ADDENDUM NO. - 04

Date: 05/08/2026

Hamilton County – Paycor Stadium
1 Paycor Stadium Cincinnati, OH 45202
Paycor Southeast/Southwest Escalators - Demolition

ITB 033-26

DRAWING NUMBER ISSUE
AD-211.4 2.3

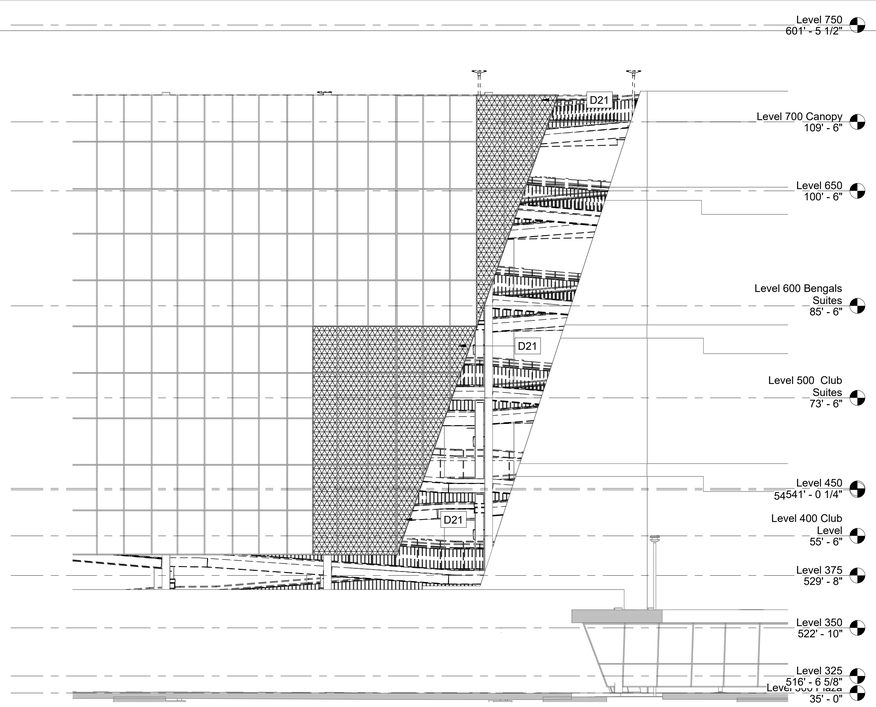
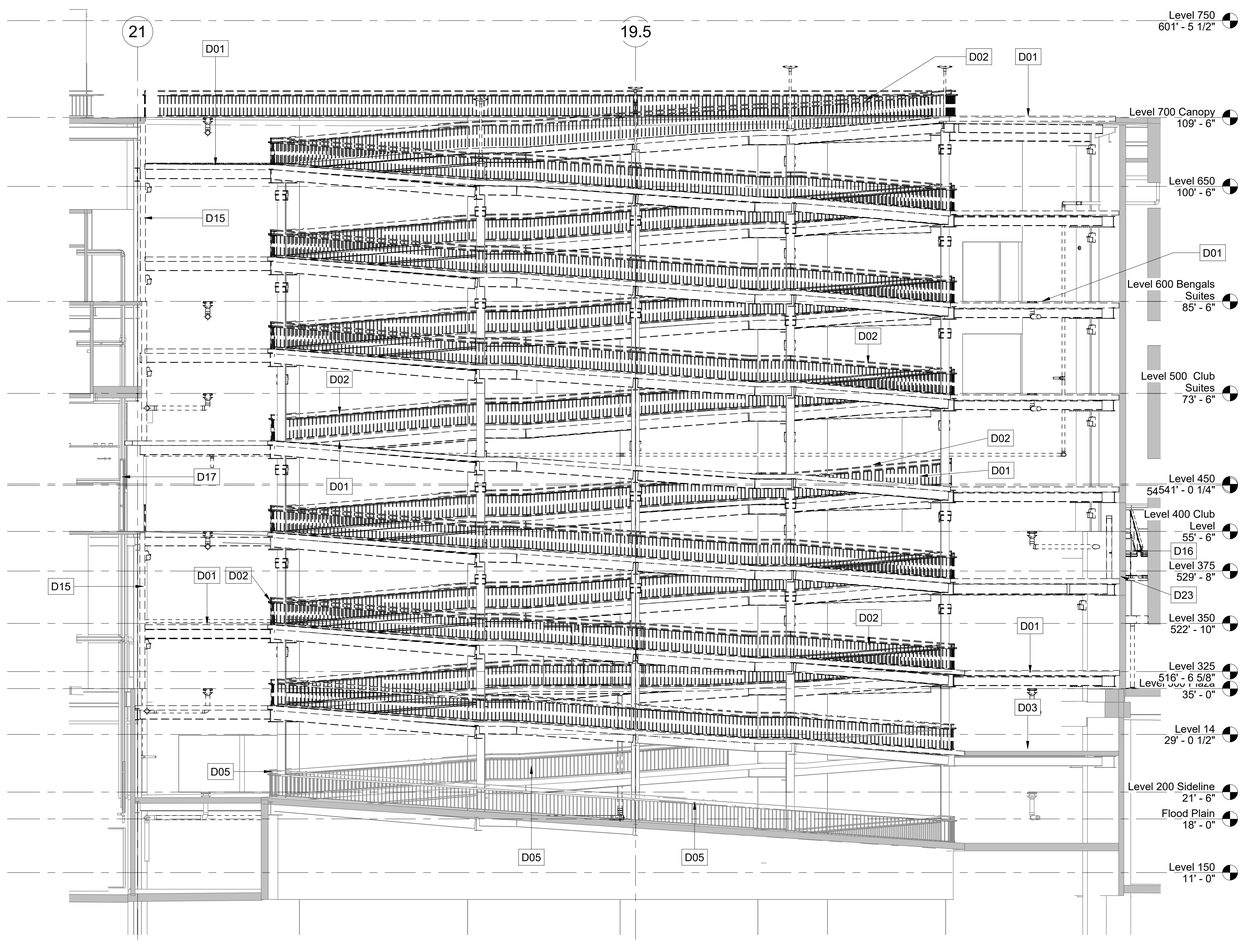
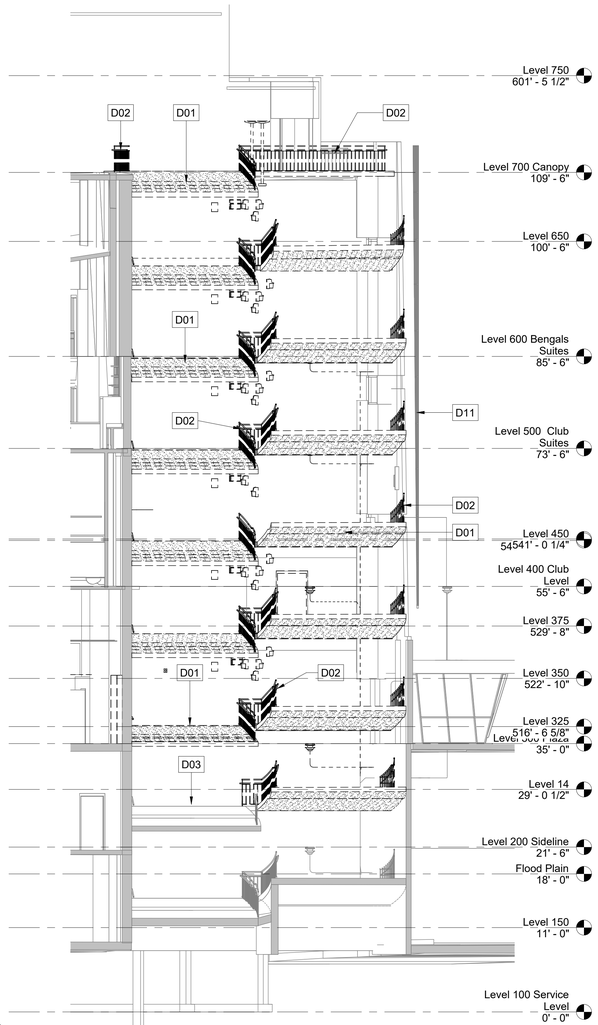
2.1.G-001: Code Summary added.
2.2.AD-102.4, AD-103.4, AD-104.4, AD-211.4, AD-106.9, AD-107.9, AD-108.9, AD-211.9:
   2.2.1. Addition to Demolition General Notes.
      J. SAVE EXISTING BRANDED FLOOR DRAIN COVERS FOR REUSE.
      K. RETURN ALL POSTERS, SIGNAGE, TO OWNER.
2.3.A-102.4, A-106.9:
   2.3.1. Revision to Door Schedule.
   2.3.2. Revision of drain locations.
   2.3.3. Addition of concrete control joints.
   2.3.4. Delineation of 1’-6” Slab hold back at Escalator apron.
2.4.A-103.4, A-107.9
   2.4.1. Revision of drain locations.
   2.4.2. Addition of concrete control joints.
   2.4.3. Delineation of 1’-6” Slab hold back at Escalator apron.
2.5.A-104.4, A-108.9
   2.5.1. Revision of drain locations.
   2.5.2. Addition of concrete control joints.
2.6.A105.4, 109.9
   2.6.1. Section/Detail markers added to Headhouse Roof plan.

DRAWING NUMBER ISSUE
A-105.4 2.4

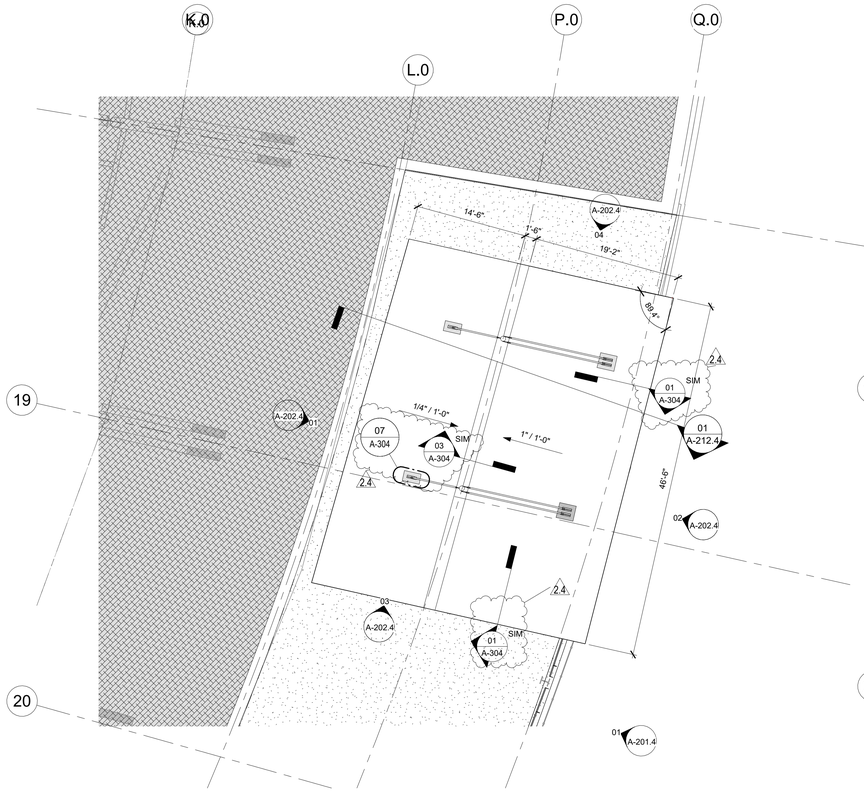
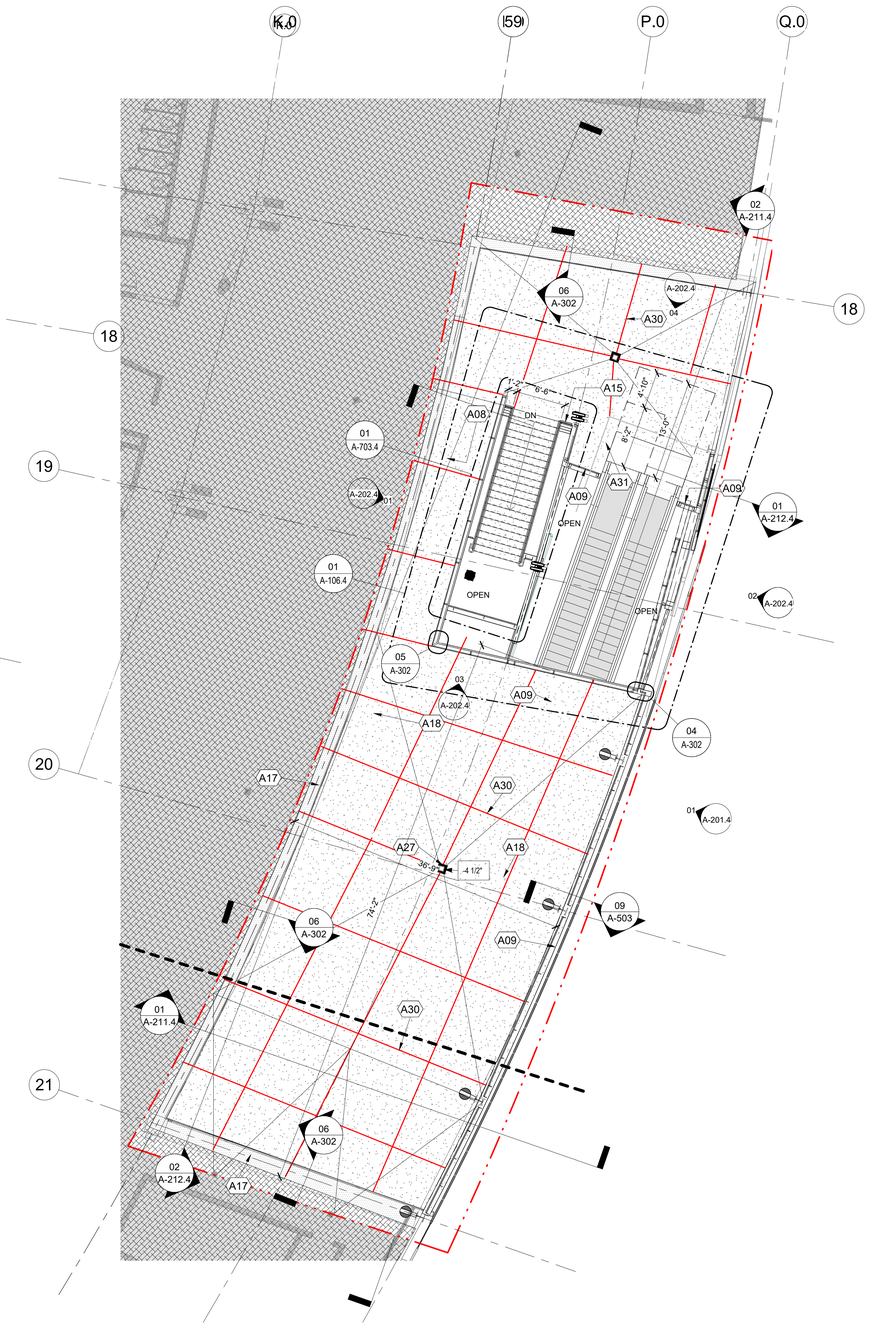
2.6.2. Revision of drain locations.
2.6.3. Addition of concrete control joints.
2.6.4. Delineation of 1’-6” Slab hold back at Escalator apron

DRAWING NUMBER ISSUE
A-202.4 2.4

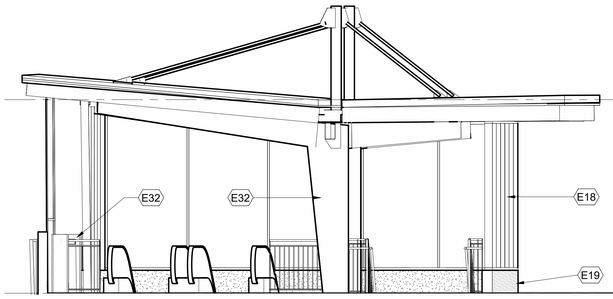
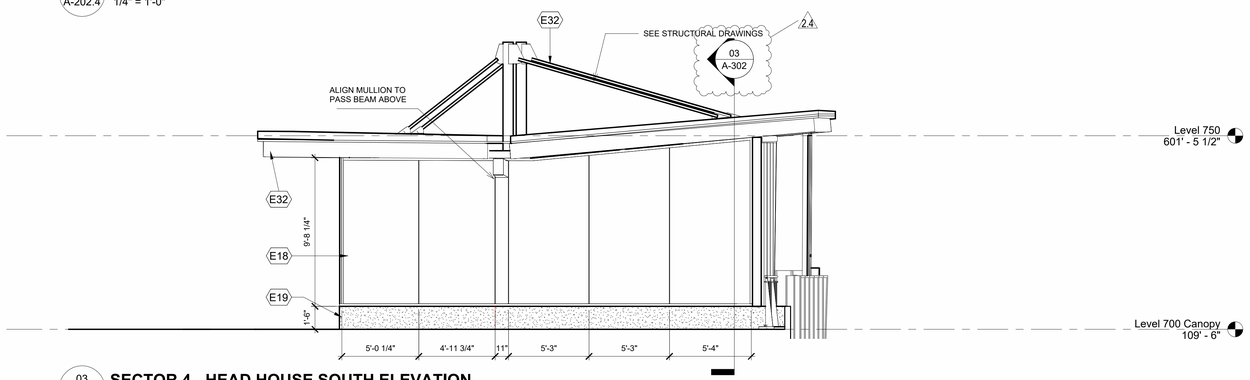
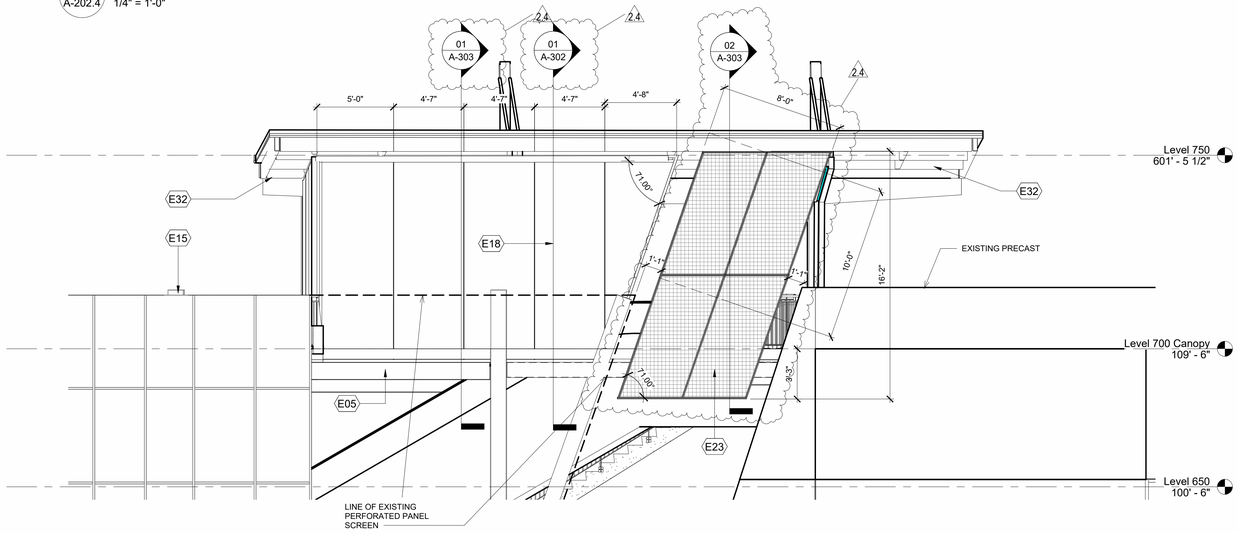
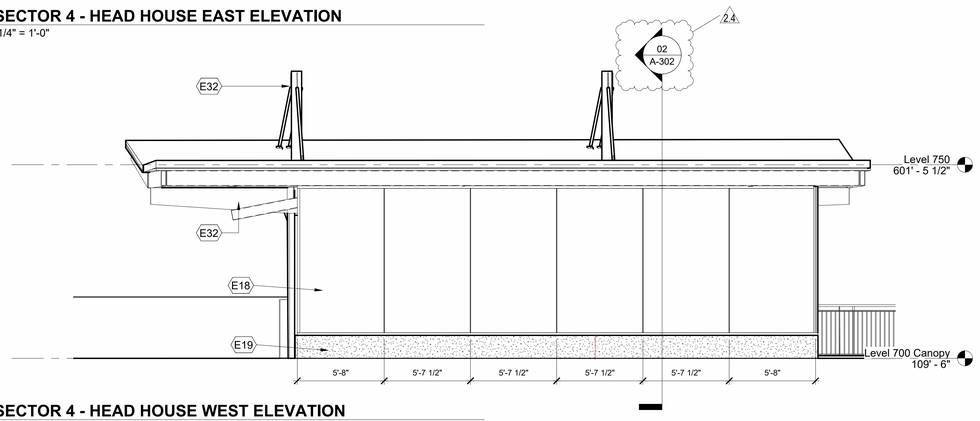
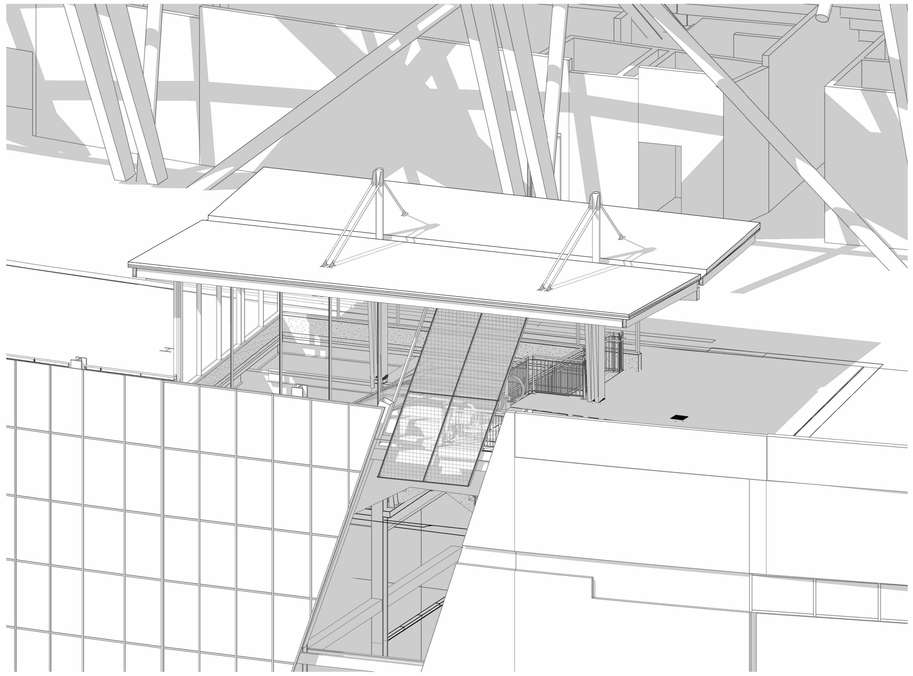
2.7.A-202.4, A-202.9
2.7.1. Revision of perforated metal screen
2.7.2. Section/Detail markers added to Headhouse Elevations.

DRAWING NUMBER ISSUE
A-213.4 2.4

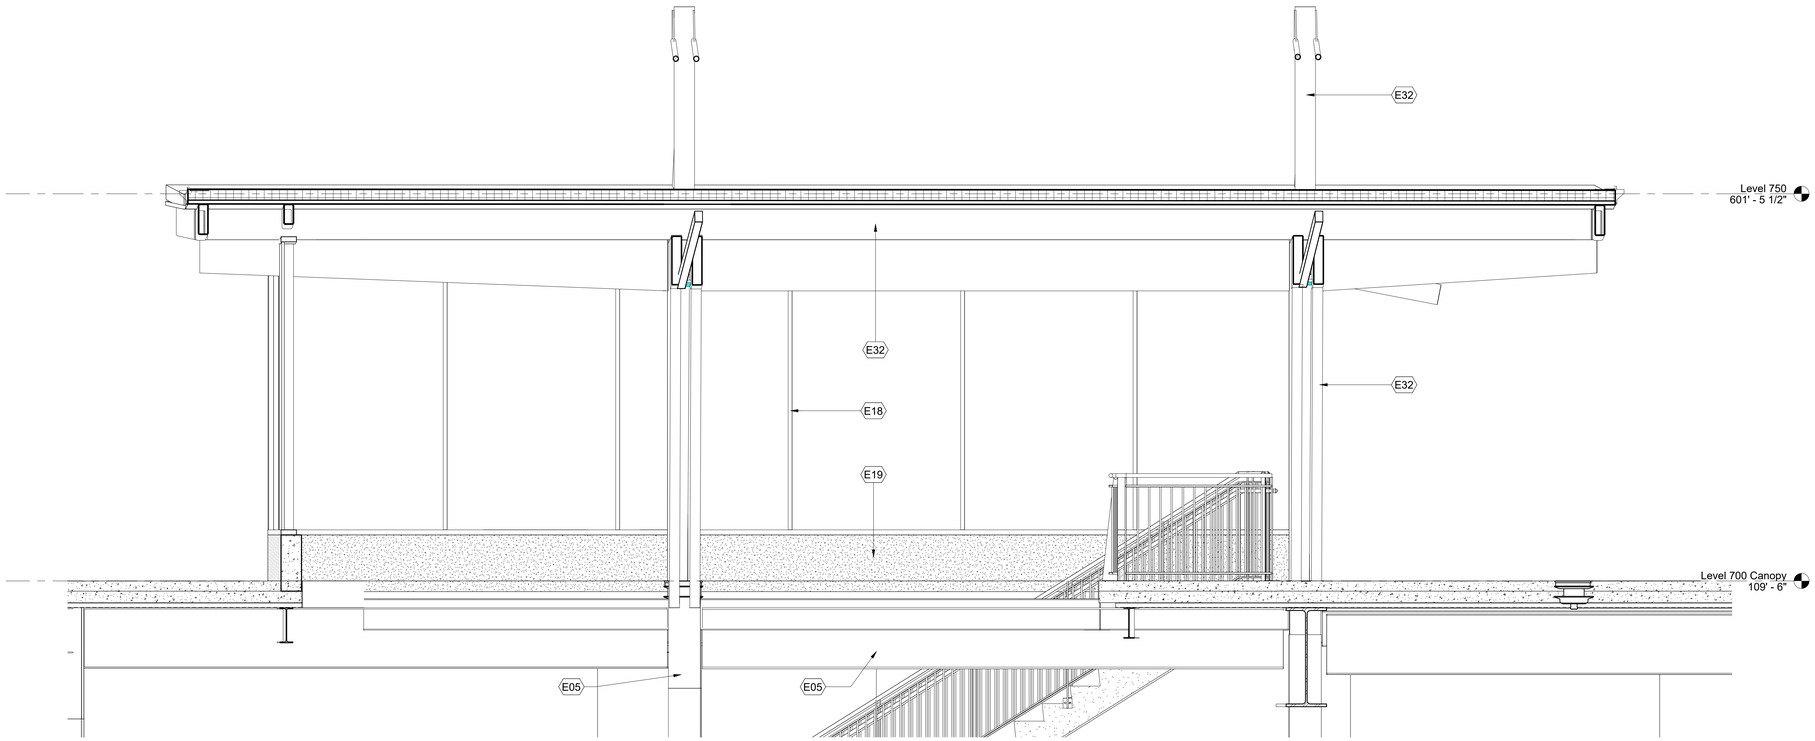
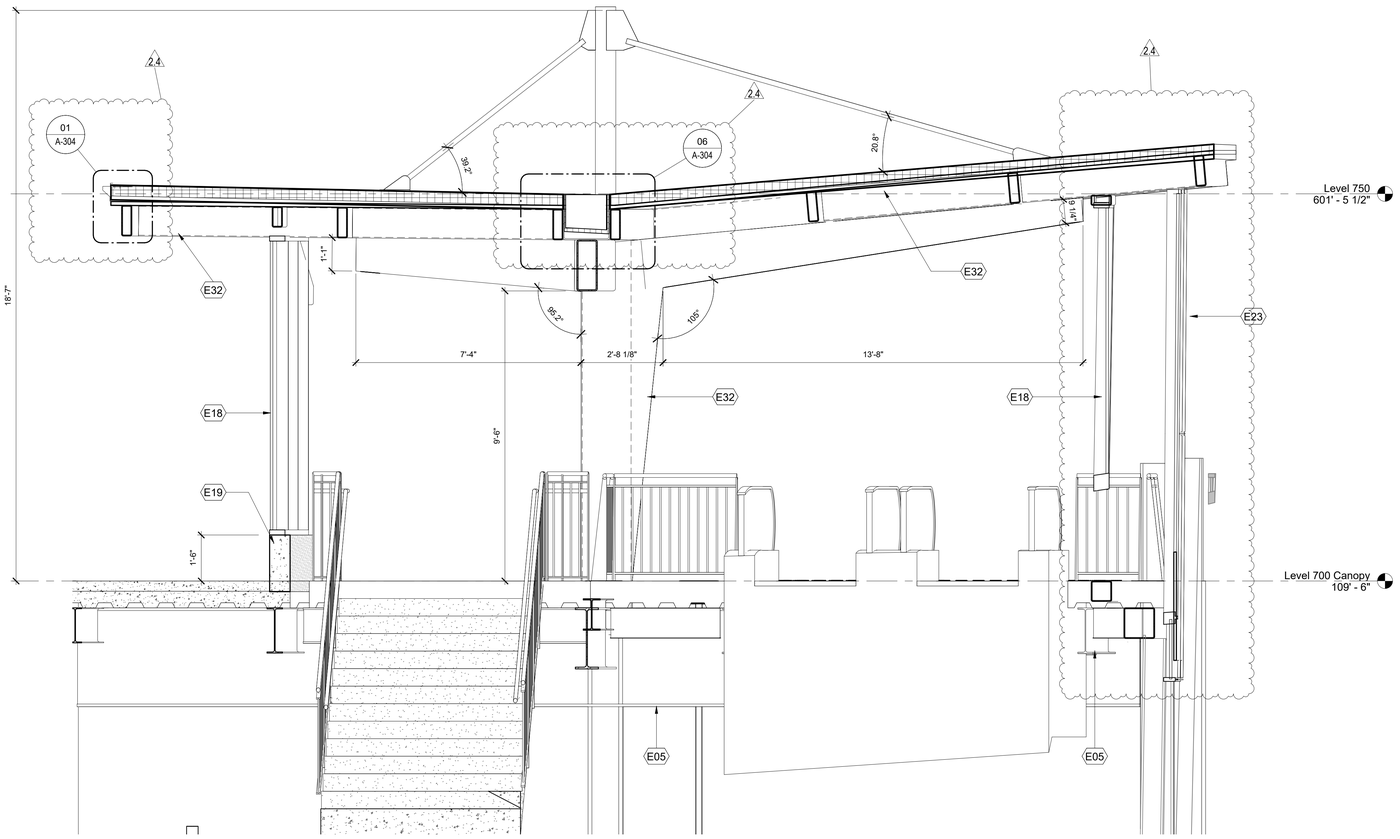
2.8.A-213.4, A- 213.9
2.8.1. Revision to center gutter.
2.8.2. Detail Markers added.
